TECHNICAL BULLETIN
Q384NAS1
13 JUN 2014

Service Action: Trailer Harness Central Junction Box Connector Pin Locations

LR4 (LA)
Model Year: 2014
VIN: EA699718-EA713882

E165757

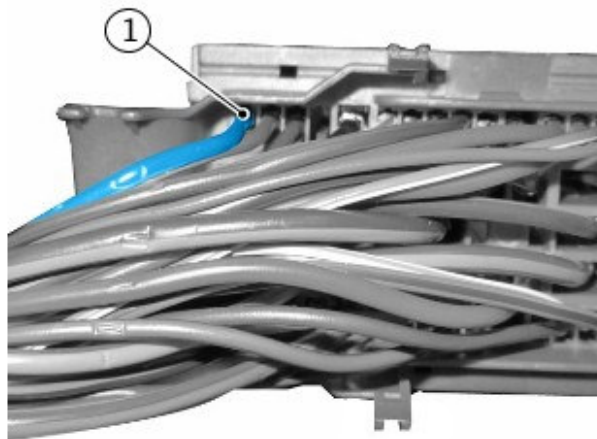
Situation: An issue has been identified on a limited number of 2014 model year LR4 (L319) vehicles within the listed VIN range where the Central Junction Box (CJB) connector has incorrect pin assignments. The CJB connector has pin location '1' wired in error where pin location '44' should be wired. If a trailer wiring harness is installed, the trailer's side and outer marker lamps do not illuminate.

7. Using the release tool 418-593 from the Terminal Repair Kit, remove the wire and terminal from cavity (1) of the connector.
